**RE: 14335 La Rinconada Drive - Parcel 1**

I reviewed the drawings, and evaluated the site context. My comments and recommendations are as follows:

## PARCEL 1 CONCERNS

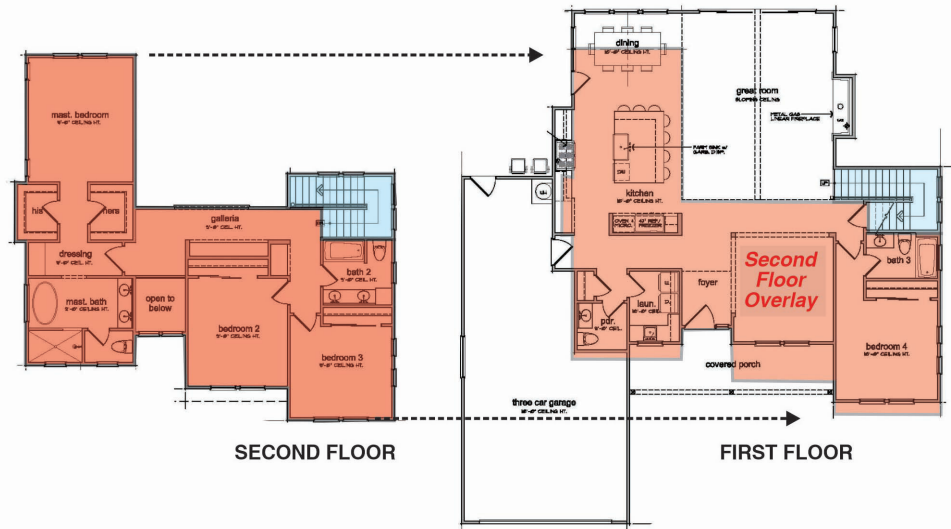
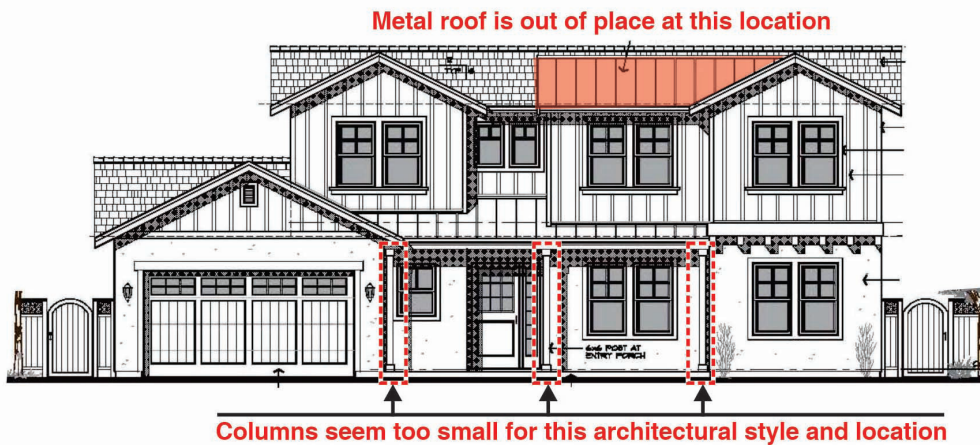
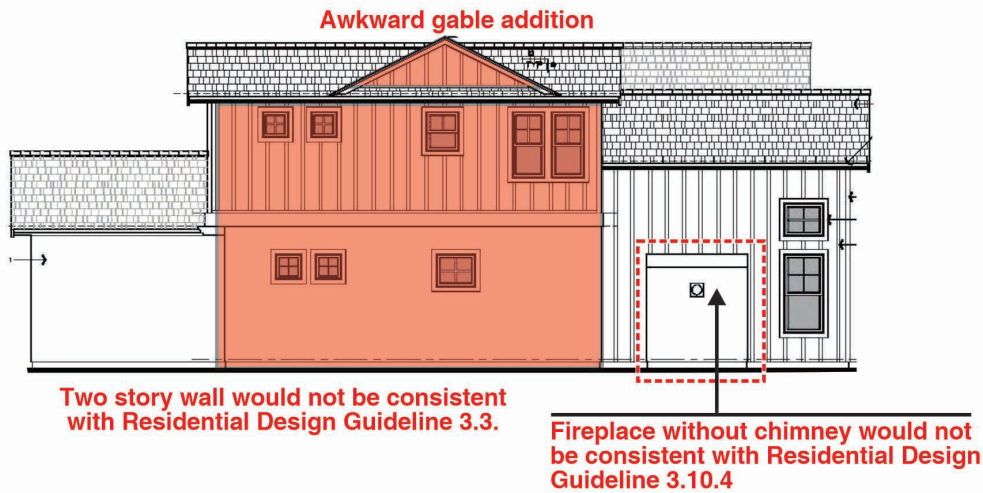
1. While a metal roof over the porch would be consistent with the proposed architectural style, its use on the upper floor would be in stark contrast to the remainder of the main roofs.
2. The proposed porch columns are too small for the size of the house and the proposed architectural style.
3. The lack of a second floor setback on the right side elevation and the resulting two story wall would not be consistent with Residential Design Guidelines 2.3.6 (above) and 3.3.3.

1. Replace second floor metal roof with shingles to match the adjacent roofs.
2. Increase the size of the entry porch columns.
3. Ensure that the fencing details shown on the front elevation are carried consistently around all the property boundaries.

4. Provide a second floor projection at Bath 2 or work with staff to find alternative means of breaking up the two story wall on the right side facade to be consistent with Residential Design Guideline 3.3.3. Alternatively, staff could request the applicant to revise the second floor plan layout to provide a setback along the right side facade.

### 3.10.4 Chimneys

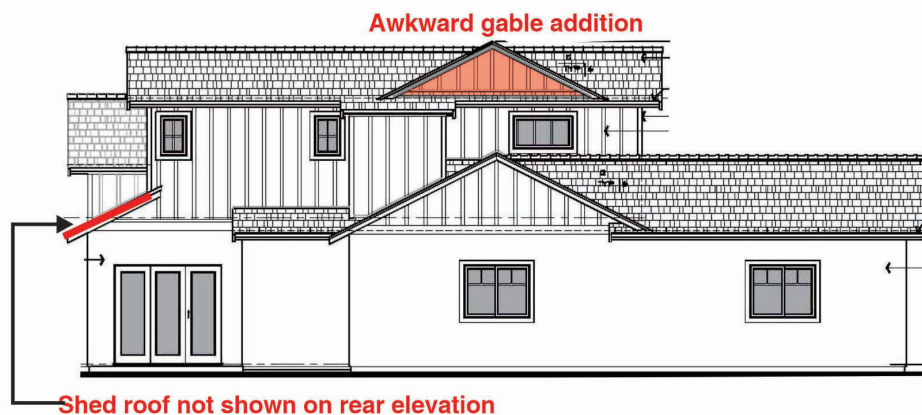
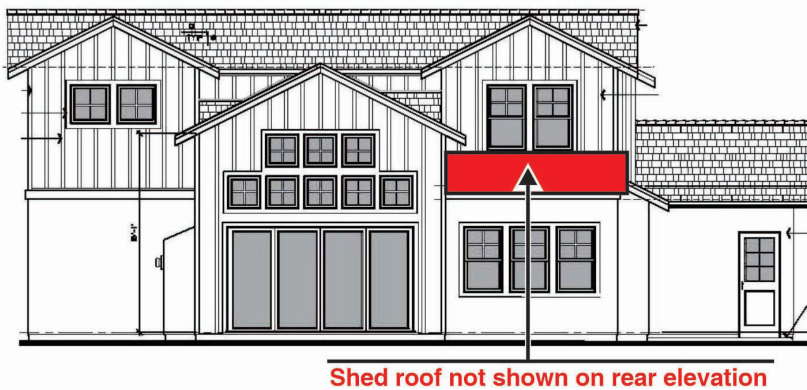
4. There are two instances where gable roof forms have been randomly added to the second floor roof in a manner not consistent with the proposed architectural style.
5. The fireplace without a traditional chimney would not be consistent with Residential Design Guideline 3.10.4.

6. A shed roof on the rear facade is not shown on that elevation.

5. Add a traditional chimney to the fireplace to be consistent with Residential Design Guideline 3.10.4.

6. Eliminate the applied second floor roof gable on the left side elevation.

7. Add the proposed first floor roof element on the rear elevation.

## PARCEL 2 CONCERNS

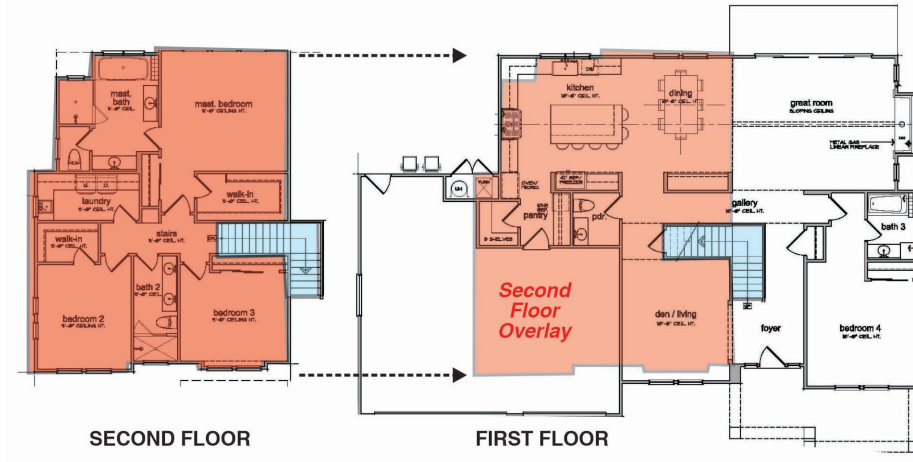
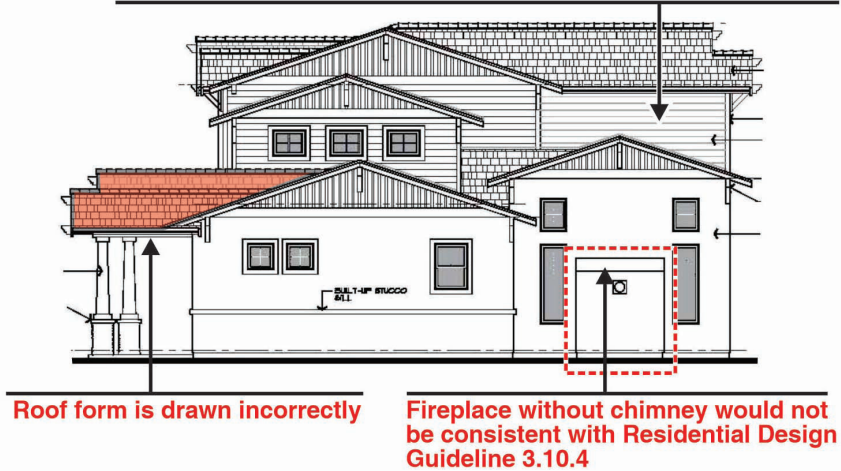
1. The rear facade is overly complex and would not be consistent with Residential Design Guideline 3.5.2. This complexity also creates a concern on the right side elevation.

**Awkward and overly complex facade is would not be consistent with Residential Design Guideline 3.5.2**

2. A minor point but the entry roof shown on the right side elevation is drawn incorrectly.
3. The fireplace without a traditional chimney would not be consistent with Residential Design Guideline 3.10.4.

**Awkward and overly complex facade here and on rear facade would not be consistent with Residential Design Guideline 3.5.2**
